April 29, 1980
TLL 203

Three Mile Island Nuclear Station, Unit II (TMI-2)
Operating License No. DPR-73
Docket No. 50-320
Mini Decay Heat Removal System Overpressurization
from Steam Generator Burp

Figure 1

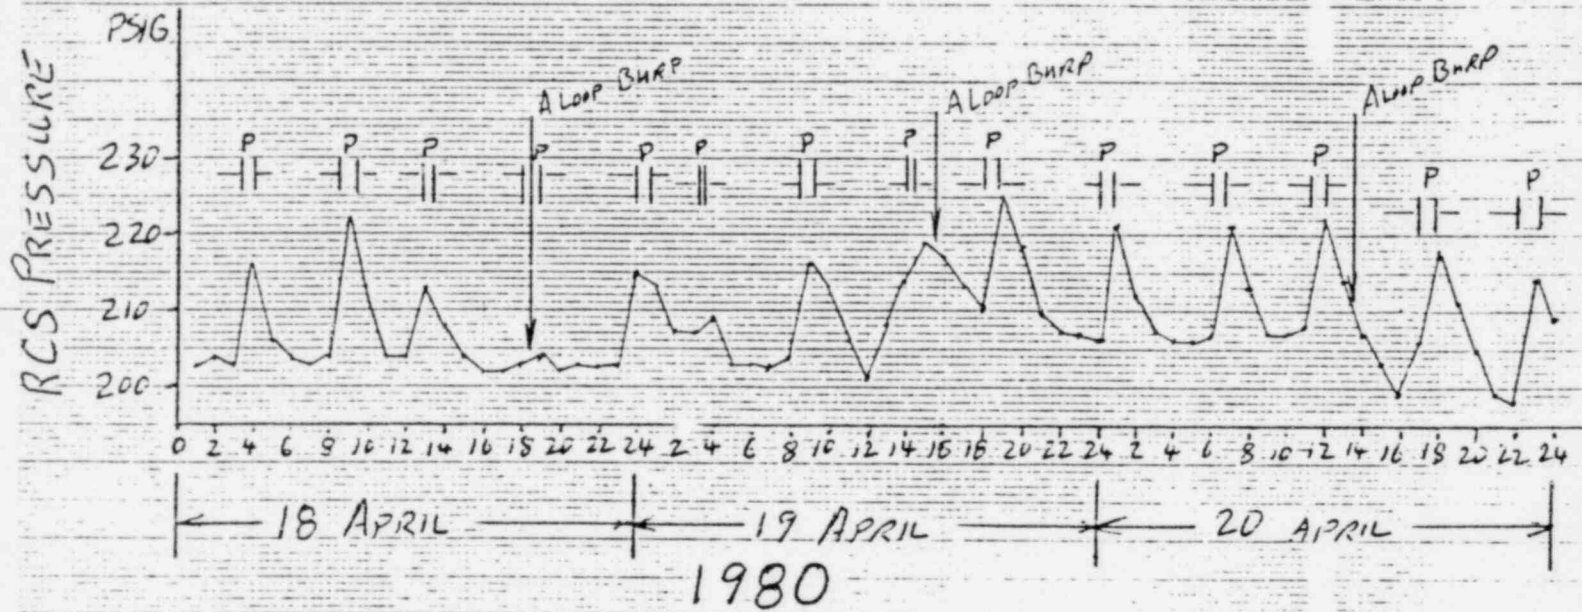
Figure 1 is a recent plot of RCS pressure. The pressure peaks coincide with (and are a direct result of) operation of the pressurizer heaters. Significantly, no RCS pressure increase can be attributed to RCS heatup following a steam generator "burp". It appears that the increase in volume attributed to RCS heatup subsequent to a "burp" is compensated for by the RCS leakage rate such that overpressurization of the system does not occur.

The analysis of this recent operating data indicates stable RCS pressures, even though intermittent RCS loop flow may occur during a steam generator "burp". Furthermore, we believe precautions to preclude steam generator "burps" and implementation of the OTSG "B" long term cooling mode to 120°F is unnecessary.
